SUBJECT: MEETING NOTIFICATION AND TRANSMITTAL OF TENTATIVE AGENDA

MAG Standard Specifications and Details Committee
TENTATIVE AGENDA
January 8, 2014

2014 PROPOSED REVISIONS TO MAG SPECIFICATIONS AND DETAILS

Case # 13-15

DETAIL NO.
200-2

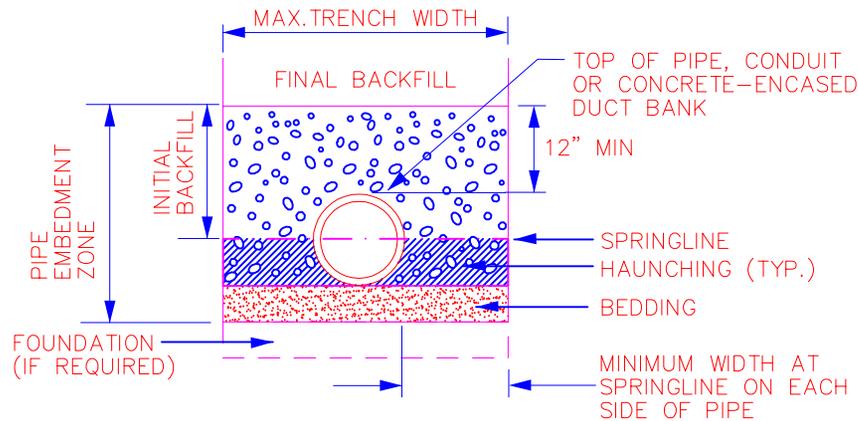
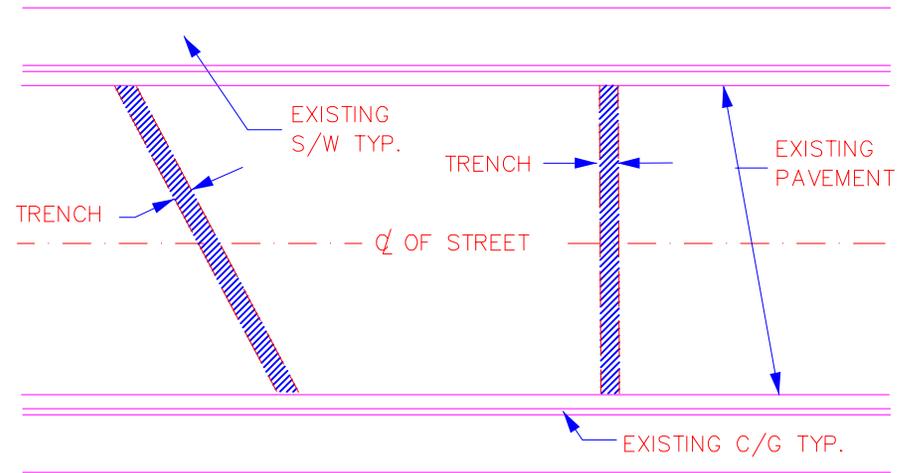
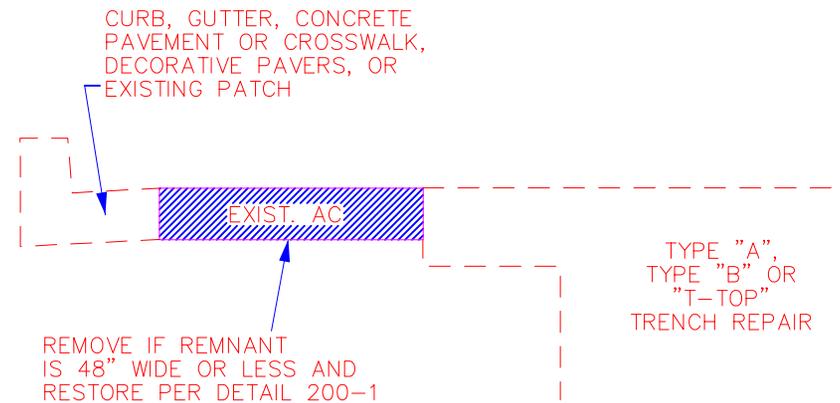
Also, the trench detail shown on Dtl 200-2 has been revamped as the "Trench Cross Section" to clearly identify the new terminology used along with other changes on both pages of this detail. Updated revision attached.

- 5) Detail 200: Backfill, Pavement and Surface Replacement
 - Revamped Trench Cross Section Detail with ASTM Terminology

DETAIL NO.
XXXX-2

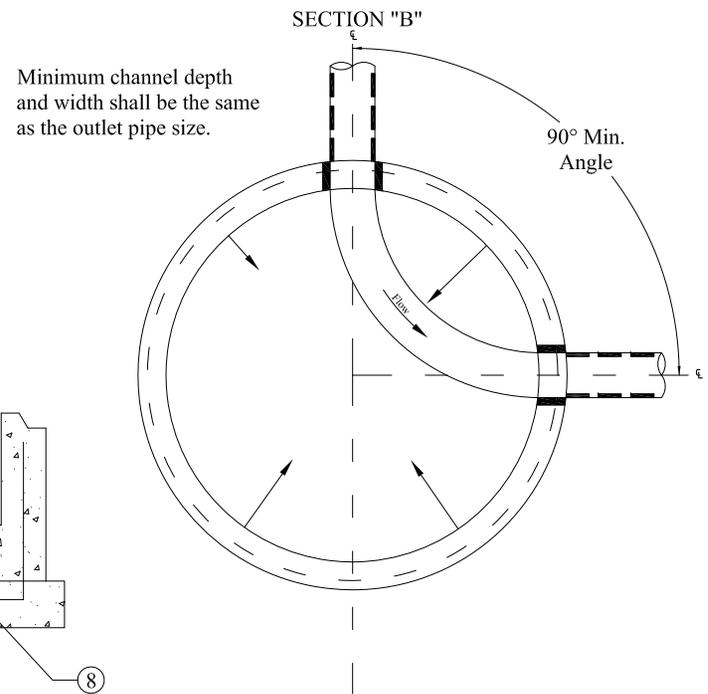
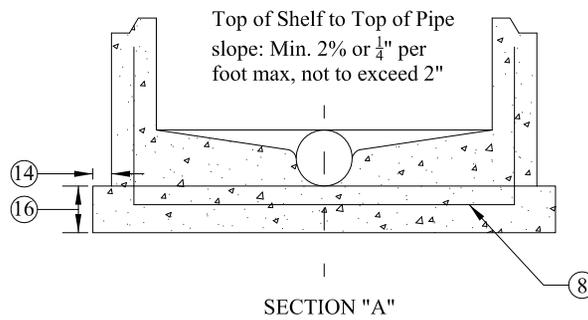
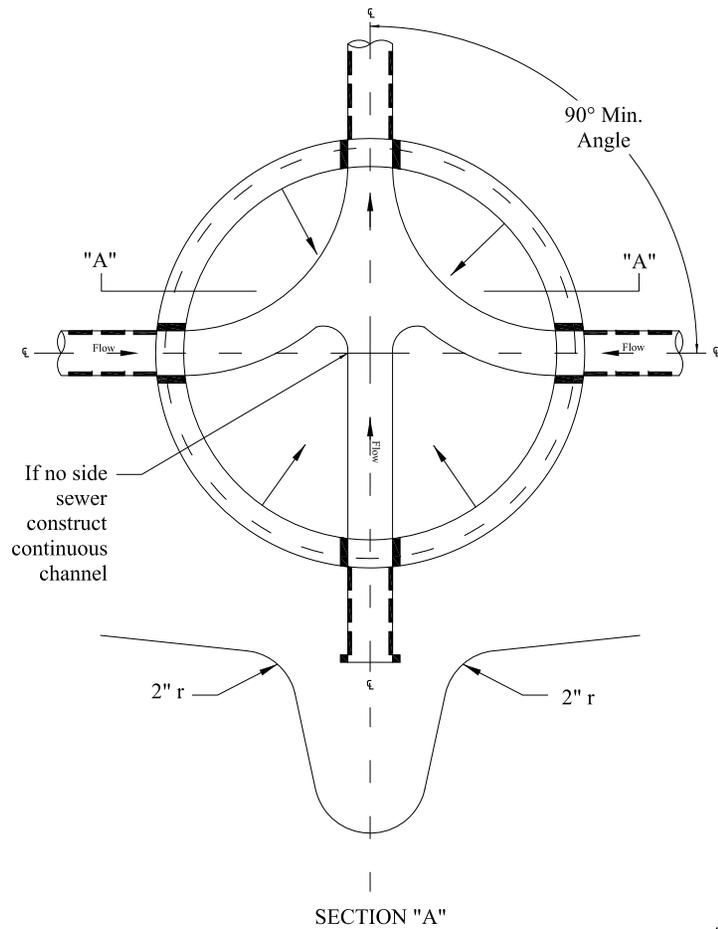
11. Case 13-21: Create a new Section 742 Pre Cast Manhole Bases. Add detail drawings for construction and installation.

Create a new section and details for pre-cast manhole bases. Craig Sharp said they are updating the current manhole details. He said these details would be further discussed at the working group meeting and said he planned to have them ready for the beginning of next year.

- ①. Pre-Cast manufacturer shall be an NPCA certified plant.
- ②. MAG "A" 4000 PSI concrete shall be used for manhole bases per ASTM C478.
- ③. Spring line of cast-in-place bell shall stop at inside face of manhole.

- ④. Joints for barrel section shall be tongue and groove or lap joint. All lifting holes shall be sealed with non metallic non-shrink grout.
- ⑤. All pre-cast manhole bases shall be placed on 10" minimum of #57 crushed rock or 8" minimum ABC compacted to 100% relative density.

- ⑥. The contractor is liable for all invert alignment and shall not make any field modifications to the base.
- ⑦. Minimum wall thickness shall be 1/12 of the largest diameter of the pre-cast manhole base plus 1".
